DESIGN AND CONSTRUCTION MANUAL DESIGN MODIFICATION REQUEST

PROJECT NAME: The Retreat at Hook Farms 2nd Plat

Re: The Retreat at Hook Farms Second Plat-Stream Buffer Variance Request

STREAM BUFFER PLAN
 SITE GRADING & SITE DISTURBANCE PLANS
 THE RETREAT AT HOOK FARMS
 SECOND PLAT

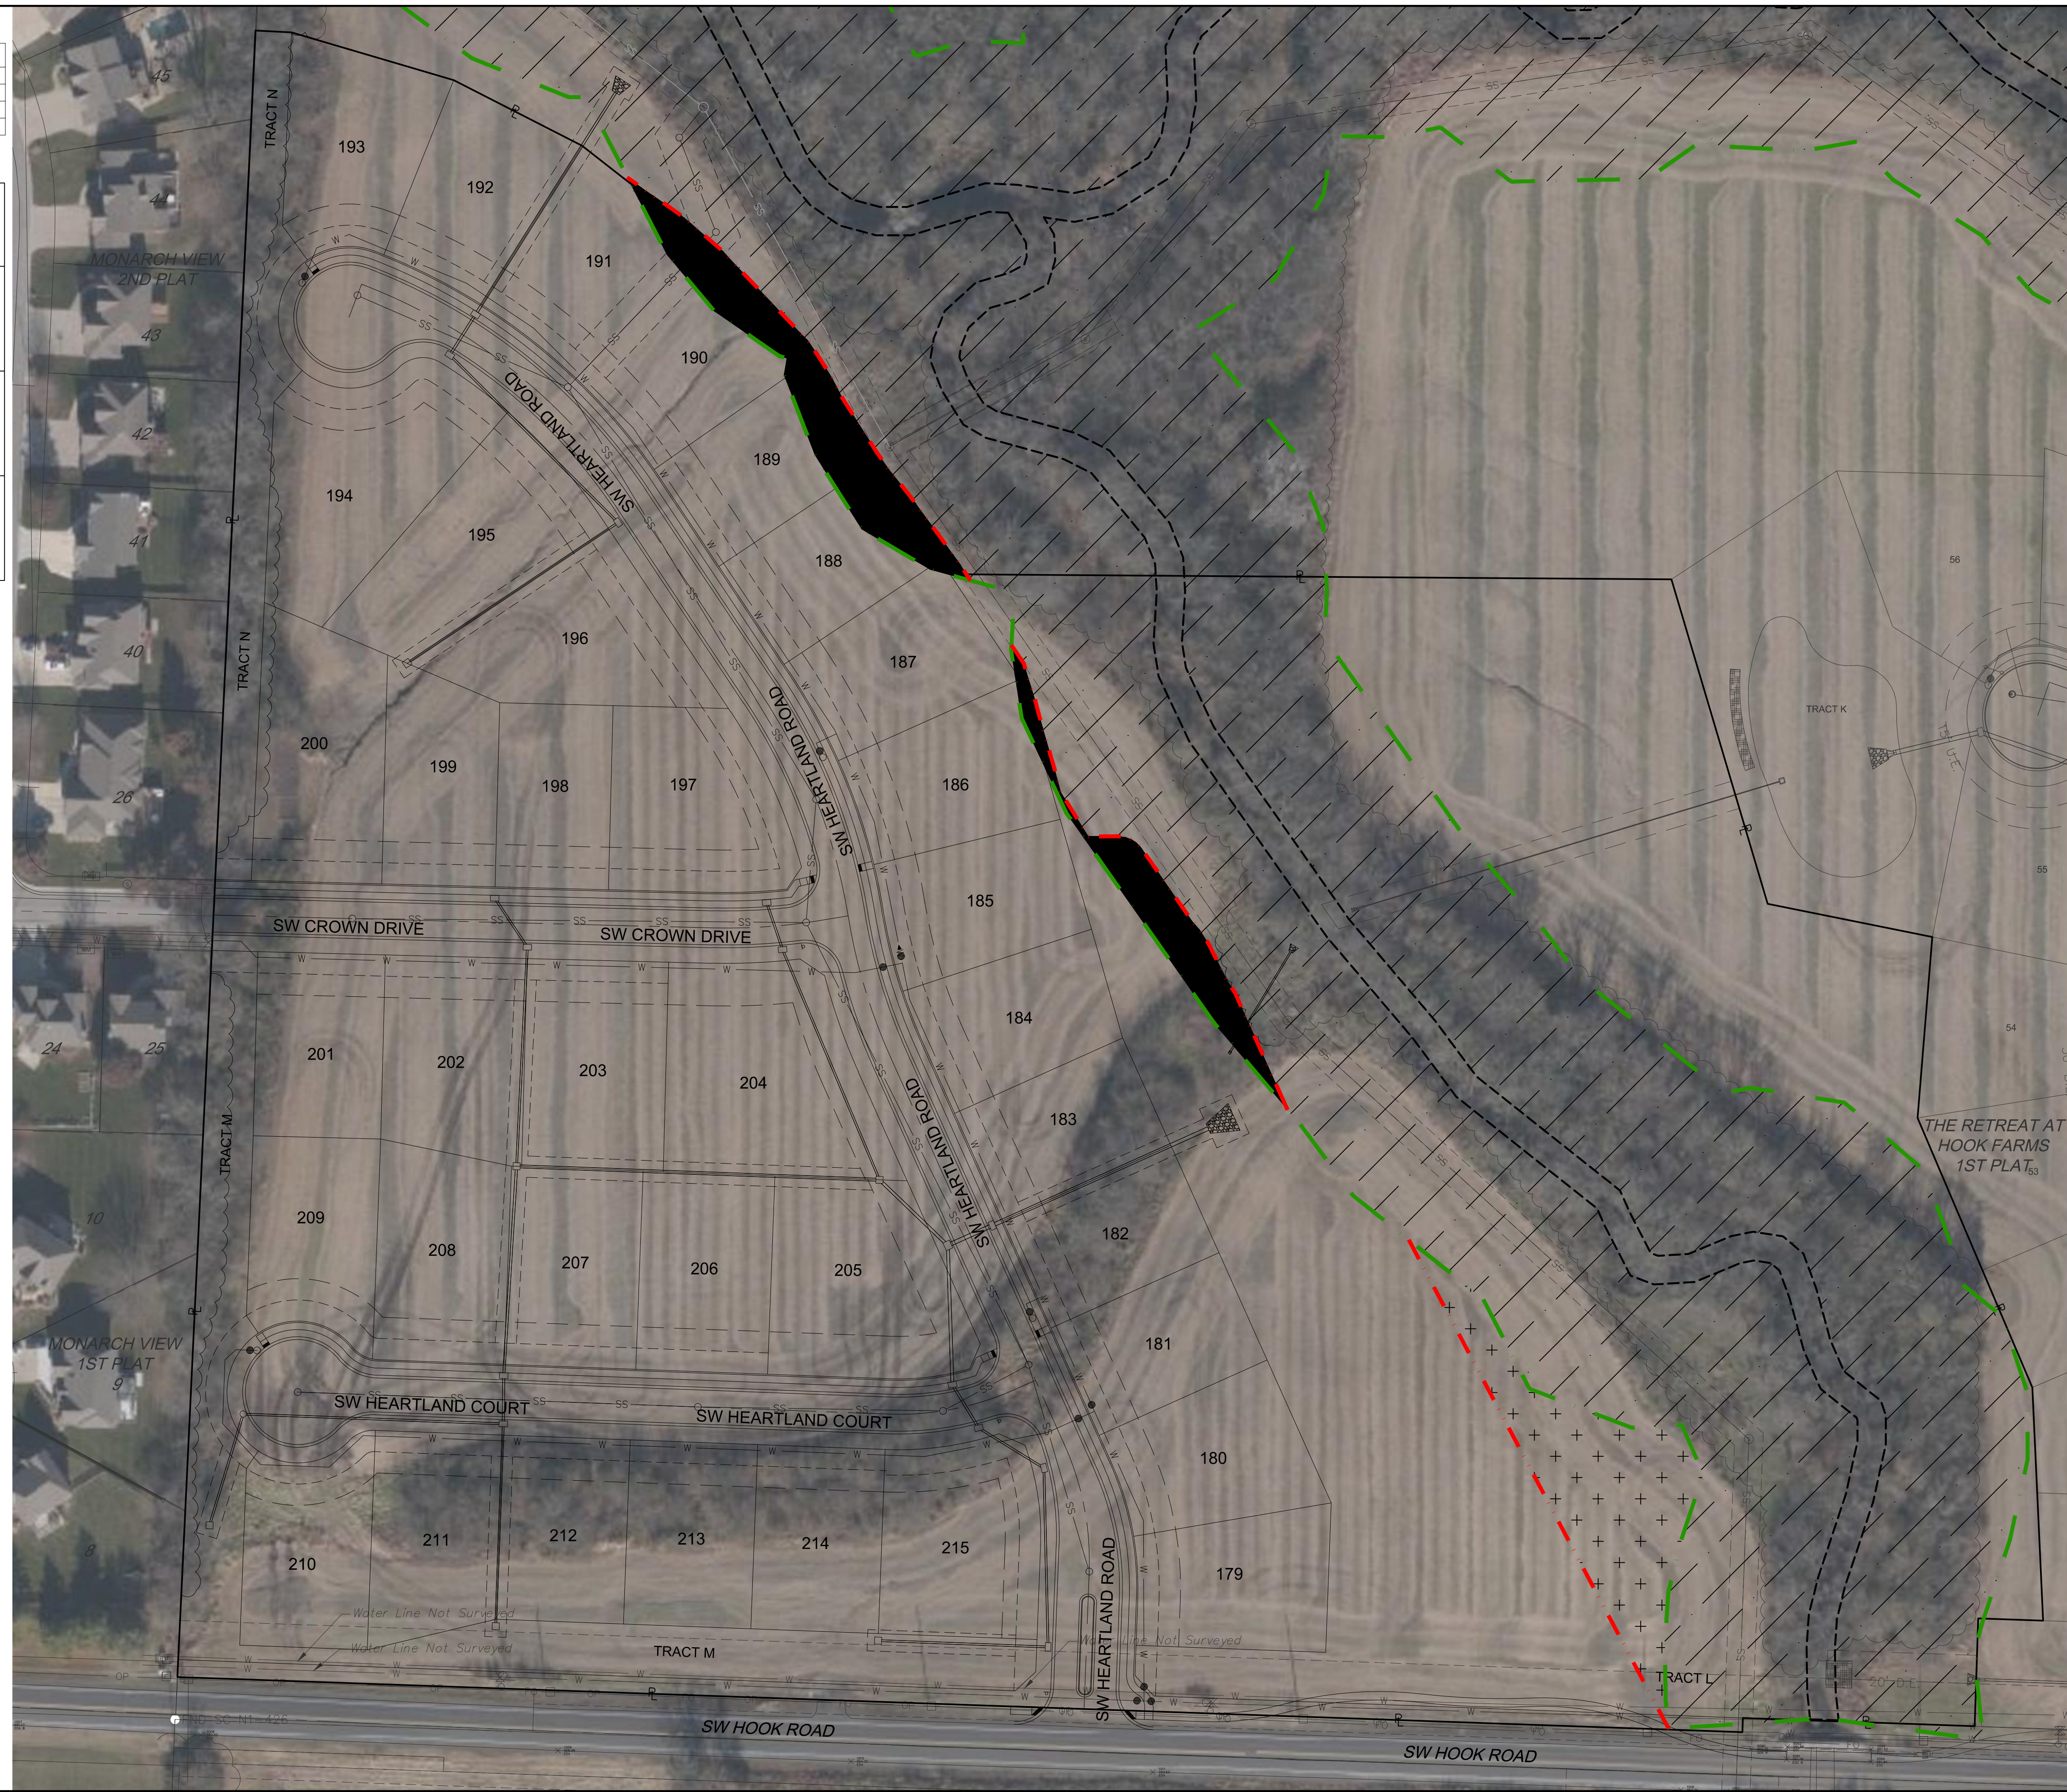
The stream buffer setbacks encroach on lots 186-191 of The Retreat at Hook Farms Second Plat. The city has requested an easement be placed over the stream buffer limits. From review of historic site imagery and site visits, this area has been under agricultural use for many years. Agricultural uses routinely disturb areas which prevents the growth of mature riparian vegetation. Due to the no active stream buffer existing in this area, we are requesting the setback zone be adjusted to remove the lot area and follow the rear lot lines.

While this request is asking to remove stream buffer setback zones, per the enclosed exhibit, this is limited to an approximate maximum setback distance of 35 feet, resulting in a total area of 0.378 acres. Areas outside of the shown disturbed limits, will maintain required setback distances and existing vegetation around the creek.

We are requesting the city approve with waiver/modification request to allow the final stream buffer setback to be reduced where it encroaches on lots, as shown in the attached exhibit. Shall you have any questions about this request please reach out to us at jsellers@olsson.com or 816.299.4340.
